Product Change Notice

PCN#: EE-PCN22007

Eaton has improved the design construction of part number 0603ESDA-MLP7, Polymer ESD Suppressor. The improved package utilizes tin-plated via-less terminals instead of the gold-plated via terminals in the current design.

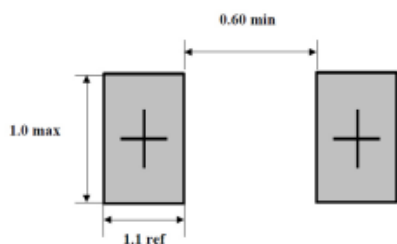
Existing Package

Improved Package

Eaton will offer two versions of the tin-plated via-less design. The 0603ESDA-MLP1 is the commercial grade version and the 0603ESDA-AEC1 is the automotive grade version. Both packages offer improved quality (solderability).

0603ESDA-MLP7 Pad Layout

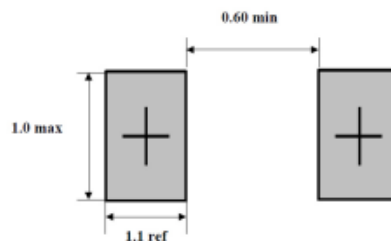
There will be no effect on the quality, reliability, or performance. There are no changes to form, fit, and function of the devices. This includes no changes to the pad layout.
